COMMENTS AND RESPONSES
FOR
PUENTE HILLS LANDFILL
REVISED WASTE DISCHARGE REQUIREMENTS
FOR
WASTE DISPOSAL, ASSESSMENT MONITORING PROGRAM, AND
CORRECTIVE ACTION PROGRAM

COMMENTS FROM COUNTY SANITATION DISTRICTS OF LOS ANGELES COUNTY:

EXHIBIT 1
TOTAL CYANIDE AT THE CANYON 9 LCRS AND THE EASTERN CANYONS LCRS
PUENTE HILLS LANDFILL

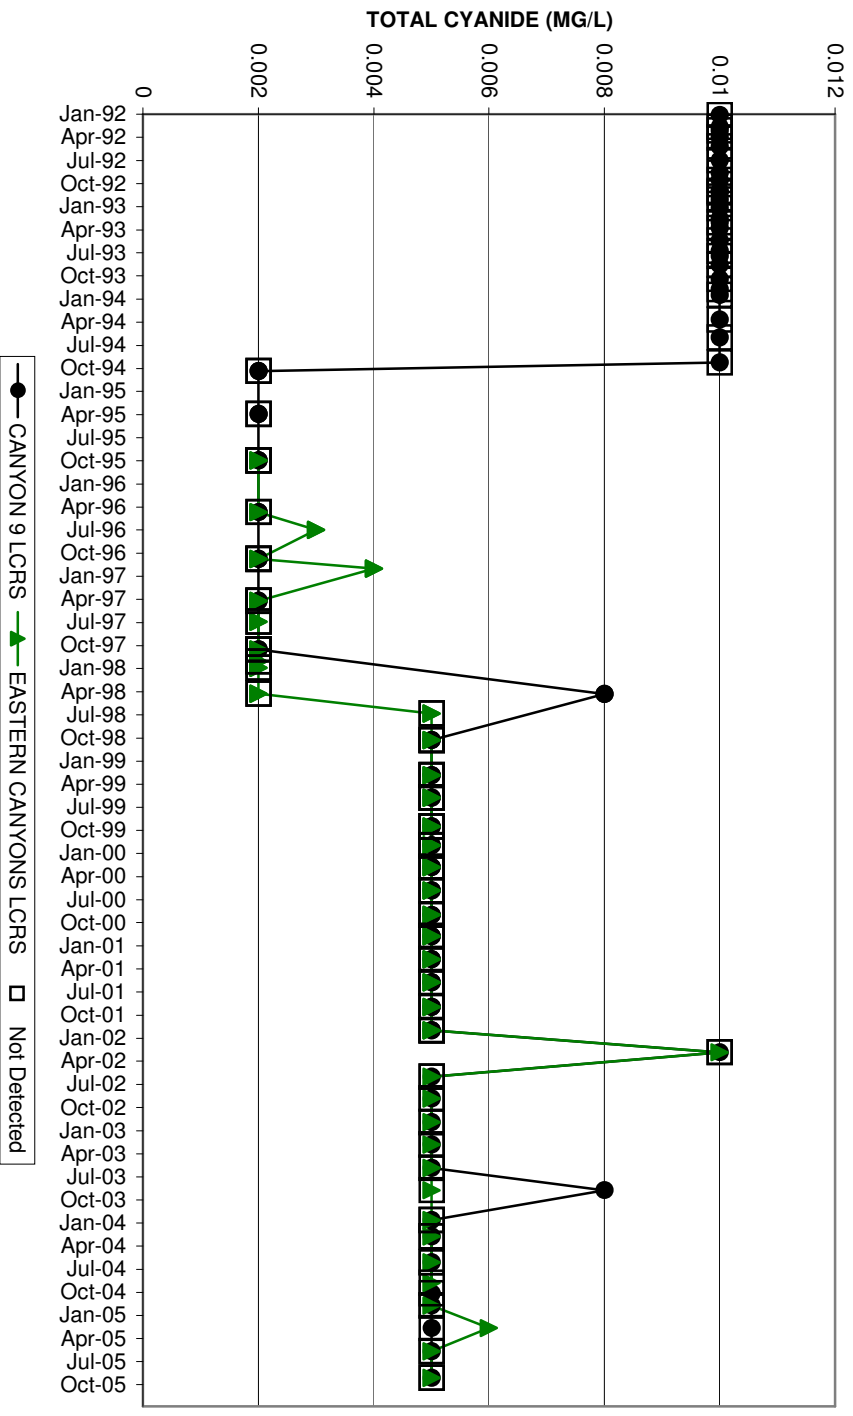
Regarding cyanide and sulfide, historical monitoring results from LCRSs indicate that these compounds are detected randomly and at low concentrations. Similar random detections have also been observed in the existing downgradient and background monitoring wells. In fact the only downgradient wells to detect sulfide those that have not been impacted any VOCs (M11A, EMP3, EMP4, EMP6, M51A, and M52B). Similarly, cyanide was primarily detected at wells not impacted by the landfill (M41A, M43A, EMP4, M51A and M52B), except for M31A and M04A. Moreover, downgradient cyanide detections were all within historical background levels. Based upon this information, we do not believe that either cyanide or sulfide are useful indicators of a potential release from the landfill. Accordingly, we would recommend that these parameters be removed from MRP Table 3. However, we again are not opposed to continued LCRS monitoring and 5-Year COC Scans for cyanide and sulfide.

The attached spreadsheet highlights total cyanide and sulfide detections in the Canyon 9 and Eastern Canyons LCRSs. As illustrated, these detections generally occur randomly and at low concentrations. Similar random detections have also been observed in the existing downgradient monitoring wells as well as in background monitoring wells (see attached pdf file). It's interesting that the downgradient monitoring wells that have detected sulfide have not been impacted any VOCs (M11A, EMP3, EMP4, EMP6, M51A, and M52B). Similarly, cyanide was primarily detected at wells not impacted by the landfill (M41A, M43A, EMP4, M51A and M52B), except for M31A and M04A. The downgradient cyanide detections were all within background levels summarized in Table 6-1 (see pdf file). Based upon this information, we do not believe that either cyanide or sulfide are useful indicators of a potential release from the landfill. Accordingly, we would appreciate if these parameters could be removed from MRP Table 3. However, we are not opposed to continued LCRS monitoring and 5-Year COC Scans for cyanide and sulfide.

Regional Board staff concurs that historical monitoring results for cyanide and sulfide in leachate samples indicate random and low concentrations (see analysis provided in attached email correspondence of October 6, 2005). Regional Board staff accepts the recommendation that these constituents not be included as monitoring parameters for compliance monitoring wells at this time but continue to be monitored for in leachate for inclusion in future scans of constituents of concern.
